I am writing with regards to the new renovated Industrialist Hotel (the Arrott Building) located at 405 Wood Street, Pittsburgh PA 15222, permit # 18-B-04848.

Application for an Encroachment on City Dedicated Right-Of-Way

Description of encroachment: Emergency Generator exhaust pipe projecting in the ROW on Fourth Ave

To: Karina Ricks, Director of the Department of Mobility and Infrastructure
From: William J. Pickering, PWSA Chief Executive Officer
Date: June 9, 2021
Subject: Proposed Encroachment at 405 Wood Street

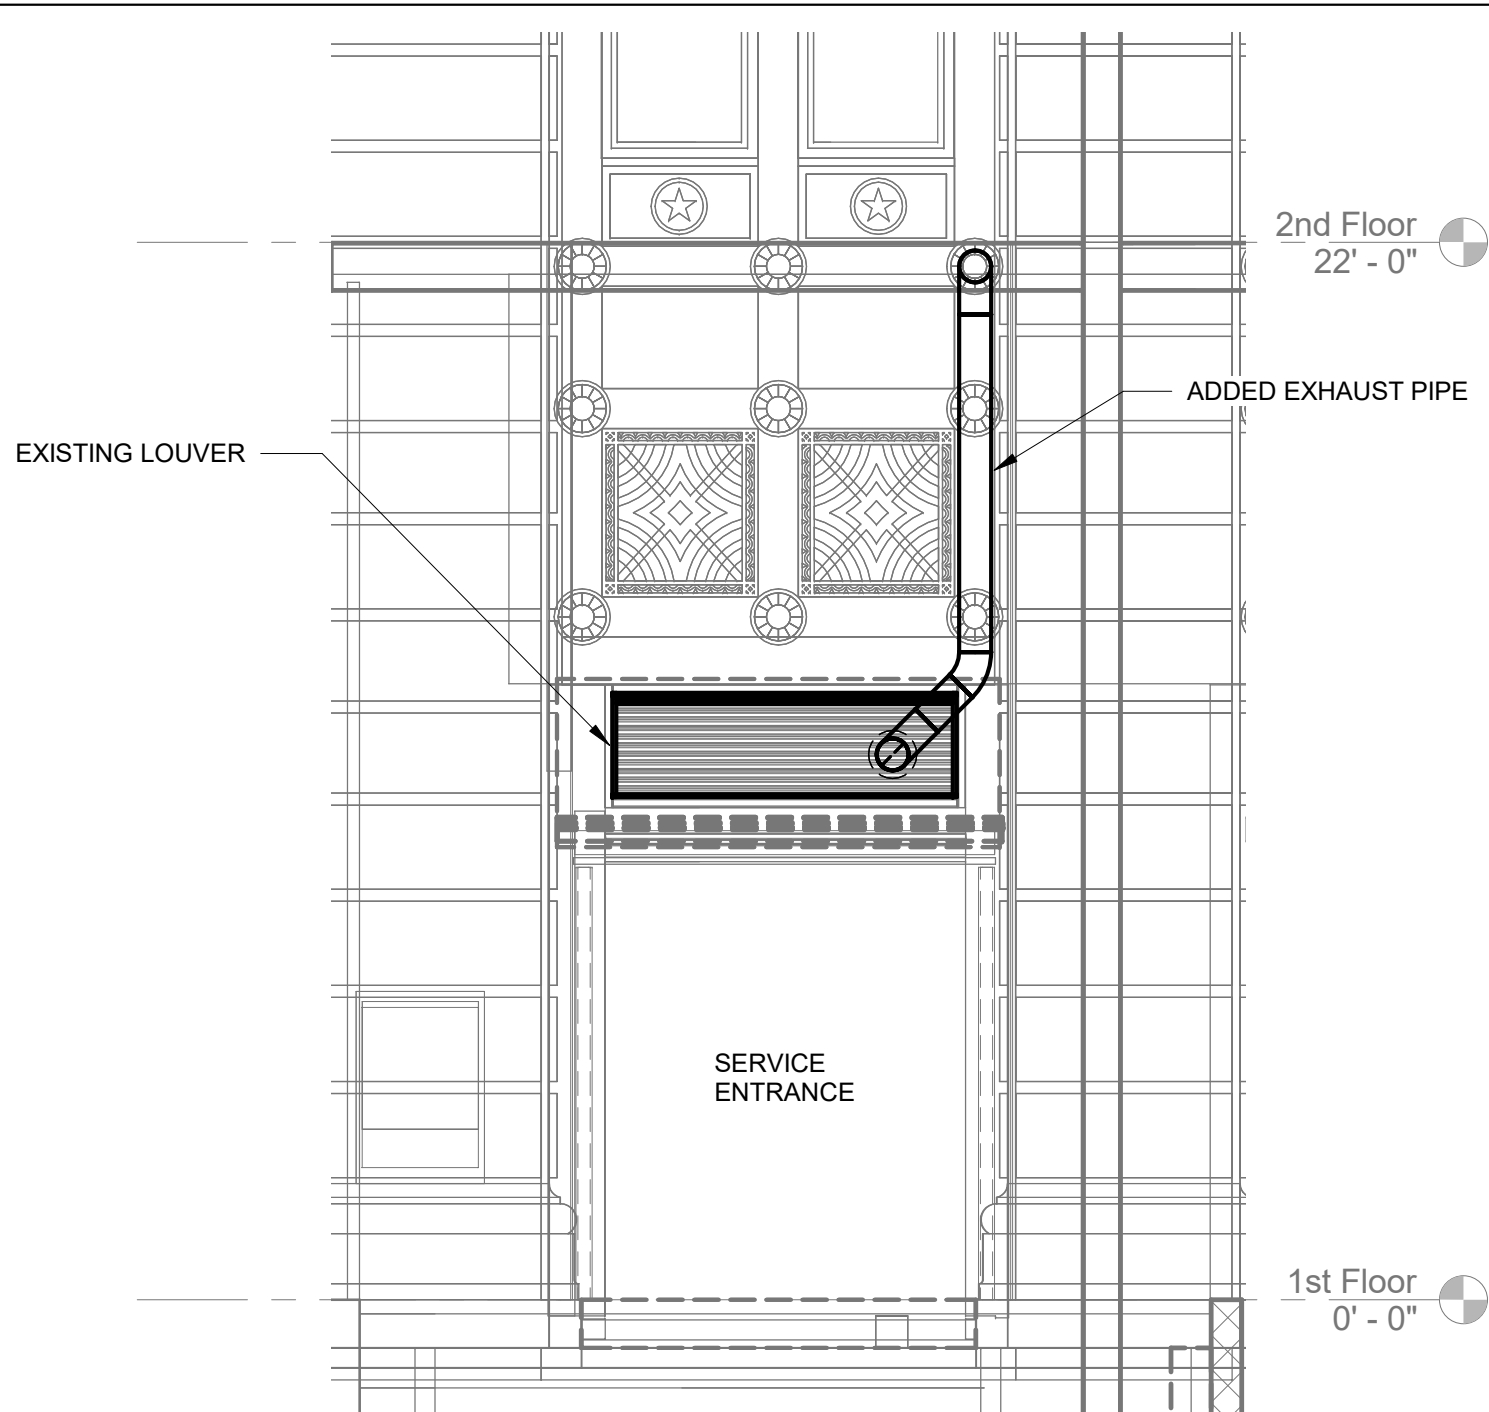
1. The Water Mapping (attached) indicates that there are no known PWSA waterlines within the area of the proposed encroachment.
2. The Sewer Mapping (attached) indicates that there are no known PWSA sewerlines within the area of the proposed encroachment that will be impacted during construction of project. Please note, PWSA does not maintain records of sewer service laterals and the property owner is responsible for maintenance. We cannot confirm if the private service lateral will be affected.

PWSA has no objection to the proposed encroachment under the conditions set forth above.
